Model: TM-100

Product Bulletin # TM-032 Rev 1

TM-100 Pressure Transducer Mounting Support

Figure 1: TM-100 Pressure Transducer

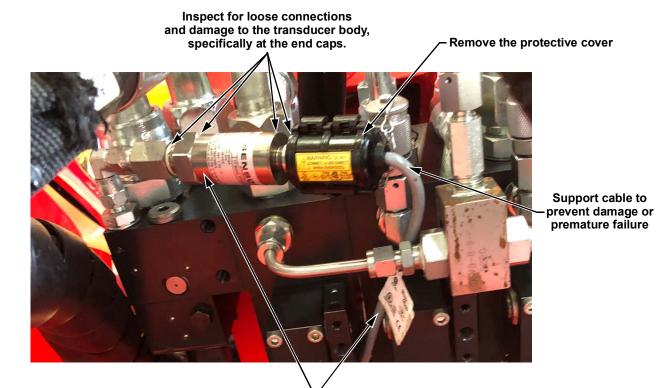
The mounting configuration of pressure transducers was recently changed on the TM-100. It has become apparent that this mounting configuration is causing transducers to fail due to excessive vibration loads reacting on the cables in the manner of which the transducers are mounted.

Weight of cable over time, can cause transducer to break.

Figure 1 shows the System Pressure transducer, please note that all pressure transducers on the TM-100 need to be inspected and supported.

- Inspect all transducers for signs of damage at the connections as well as along the body of the transducer itself, especially at the end caps of the transducer.
- Ensure the weight of the cable at connection of transducer is supported as to not put undue weight onto the end of the transducer.
- Remove the protective cover over the M12 connector to reduce stresses on the connection.

Figure 2: TM-100 Pressure Transducer Map

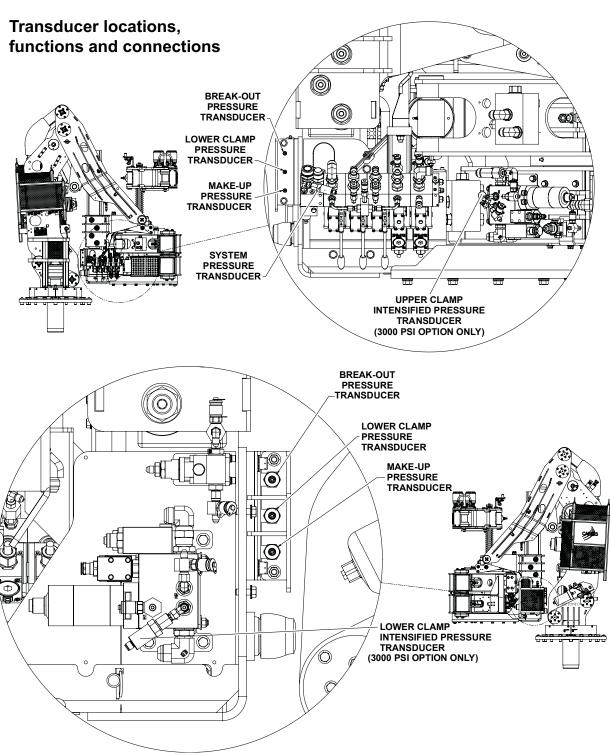
- TM-100, 3,000 psi 6x Pressure transducers total
- TM-100, 5,000 psi 4x Pressure transducers total

See Figure 2 on page 3 for pressure transducer locations on the Wrench.
